RE: Juneau Douglas North Channel Crossing Project

Juneau International Airport (JNU) has been part of the Technical Advisory Committee (TAC) for the Juneau Douglas (JD) North Channel Crossing project since the project was resurrected a few years ago. JNU has submitted comments since the beginning of the PEL study requesting that the JNU airport approach corridors be protected. Because JNU's comments do not appear to have been included in the summary of comments, please use this letter as our formal comment on the JD North Crossing for options that could negatively impact JNU airport.

## PRELIMINARY ALTERNATIVES

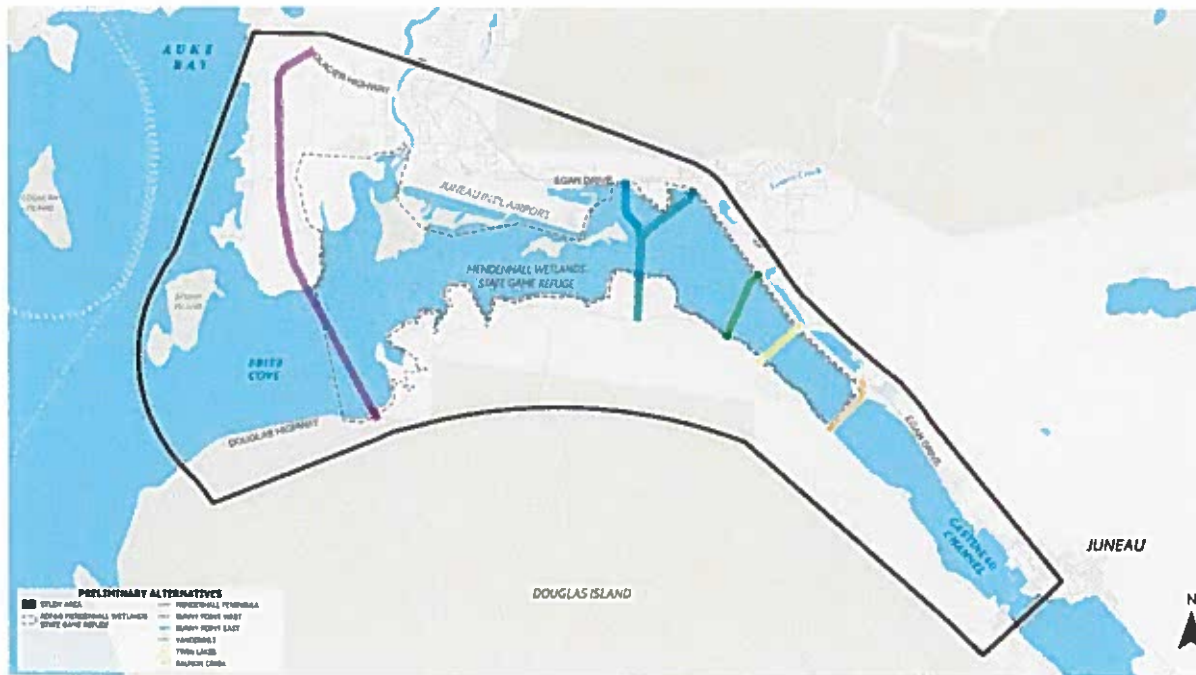
On the west end, the Mendenhall Peninsula option, while unknown height, would require navigable heights for boats. This height would have to be considered for aircraft sequencing to land at JNU holding outside of Class D airspace during inclement weather or heavy traffic (float planes and small planes that hold/circle in this area).

On the east end, at final build, the Sunny Point option(s) may impact the approaches to RWY 26. The construction **WILL** impact the approaches to RWY 26 because any pilings/crane work will be an obstruction to airspace.

The Juneau International Airport Board requests that the Juneau Douglas North Crossing not include an option that would negatively impact runway approaches and the safety of the airport and traveling public. The Board requests that the Mendenhall Peninsula, Sunny Point Options, and any other options that are found to conflict with airport approaches be eliminated from the study as non-viable options.
